SUNDRY NOTICES AND REPORTS ON WELLS (DO NOT USE THIS FORM FOR PROPOSALS TO DRILL OR TO DEEPEN OR PLUG BACK TO A DIFFERENT RESERVOIR. USE "APPLICATION FOR PERMIT" (FORM C-101) FOR SUCH PROPOSALS.)		WELL API NO. 30-015-23816
1. Type of Well: Oil Well ☐ Gas Well ☒ Other SWD		5. Indicate Type of Lease STATE ☒ FEE ☐
2. Name of Operator WPX Energy Permian, LLC		6. State Oil & Gas Lease No. 38754
3. Address of Operator 3500 ONE WILLIAMS CENTER MD 35 TULSA, OK 74172		7. Lease Name or Unit Agreement Name SWEARINGEN
4. Well Location Unit Letter J : 1650 feet from the SOUTH line and 1980 feet from the EAST line Section 04 Township 23S Range 28E NMPM EDDY County		8. Well Number #001
11. Elevation (Show whether DR, RKB, RT, GR, etc.) 3,104' GR		9. OGRID Number 246289
		10. Pool name or Wildcat SWD; BONE SPRING

WPX ENERGY PERMIAN, LLC requests to P&A the above referenced well.

WELLBORE DIAGRAM - CURRENT

CONDITIONS FOR PLUGGING AND ABANDONMENT

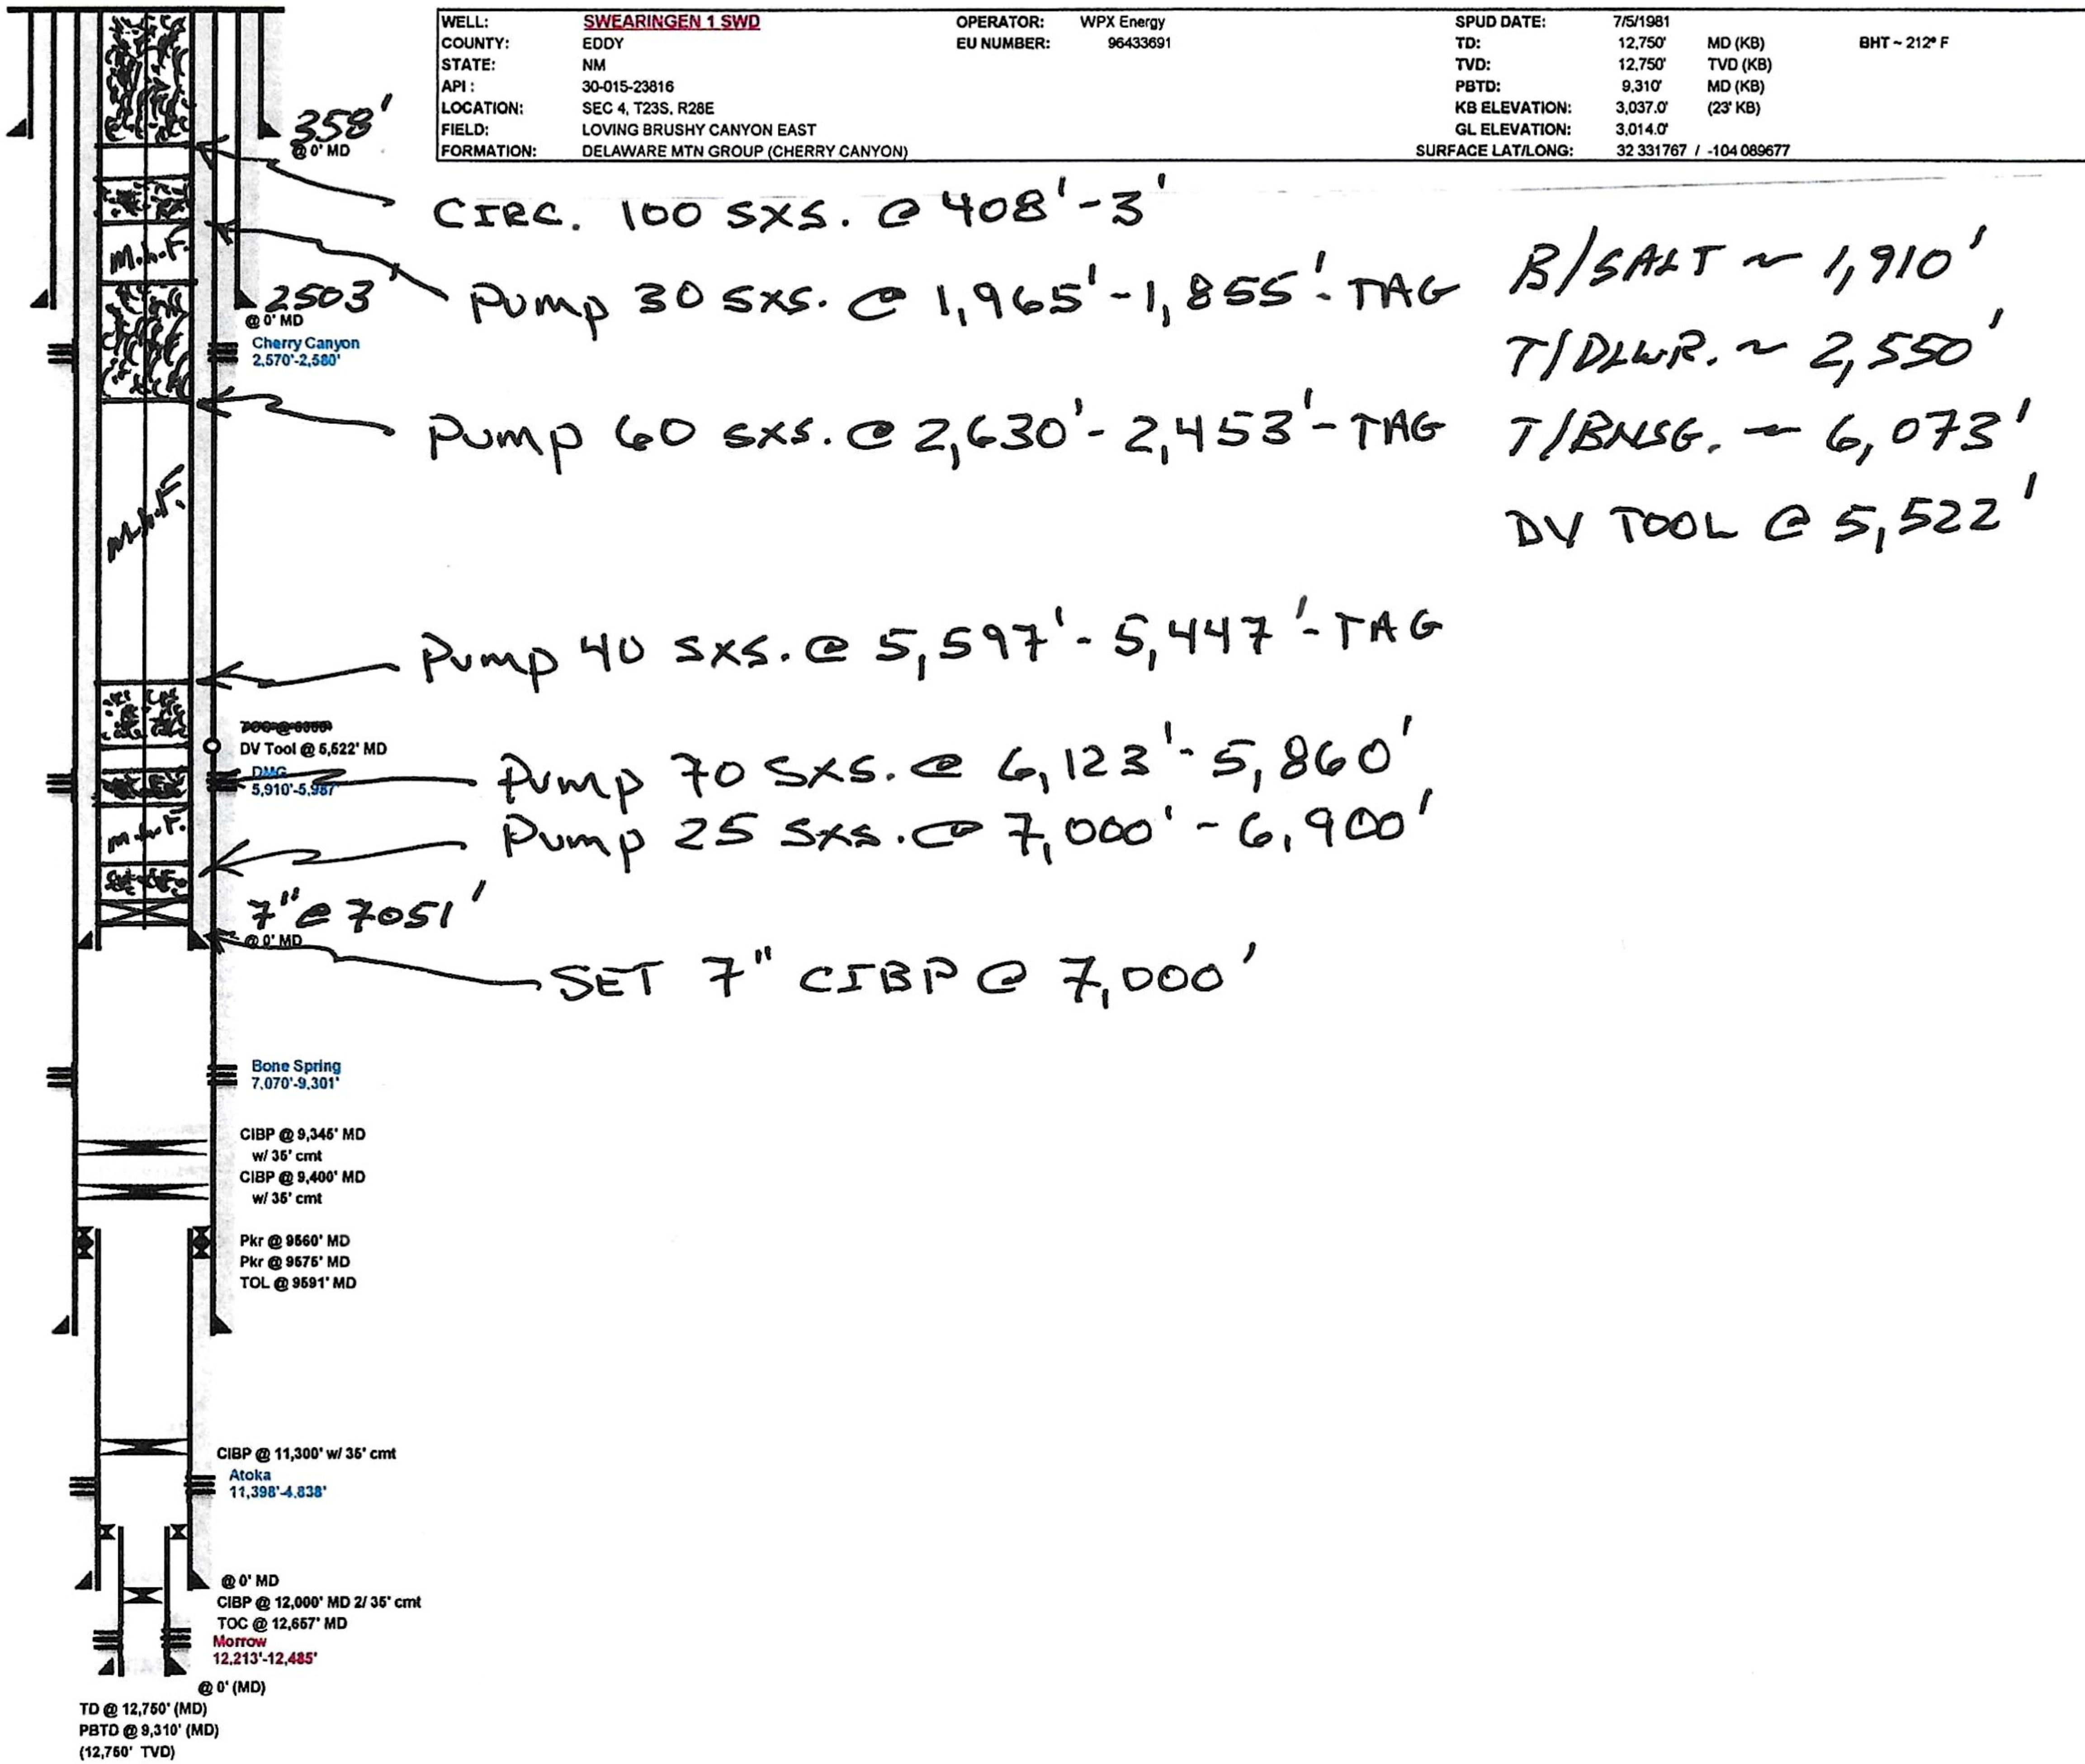
WOC & Tag

- 1) SET 7" CIBP@ 7,000'; CIRC. WELL WI M.L.F.; PRES. TEST 7" CSG. TO 750#; PUMP 25 SXS. CMT.@ 7,000'-6,900'.
- 2) PUMP 70 SXS. CMT.@ 6,123'-5,860' (T/BNSG., DMG PERFS.). **Must tag at 6020'**
- 3) PUMP 40 sxs. CMT.@ 5,597'-5,447' (9-5/8" DV TOOL); woe X TAG TOC.
- 4) PUMP 60 sxs. CMT. @2,630'-2,453' (CCYN PERFS., TI DLWR., 13-318" CSG.SHOE); woe X TAG TOC.
- 5) PUMP 30 sxs. CMT.@ 1,965'-1,855' (BISALT); woe X TAG TOC.
- 6) MIX X CIRC. TO SURF. 100 SXS. CMT. @408'-3'. **Perf @ 408' & attempt to circ cmt to surface.**
- 7) DIG OUT X CUT OFF WELLHEAD 3' B.G.L.; WELD ON STEEL PLATE TO CSGS. X INSTALL DRY HOLE MARKER.
- 8) DURING THIS PROCEDURE WE PLAN TO USE A CLOSED-LOOP SYSTEM WI A STEEL TANK AND HAUL CONTENTS TO THE REQUIRED DISPOSAL, PER OCD RULE 19.15.17.

Must be plugged by 6/18/2022
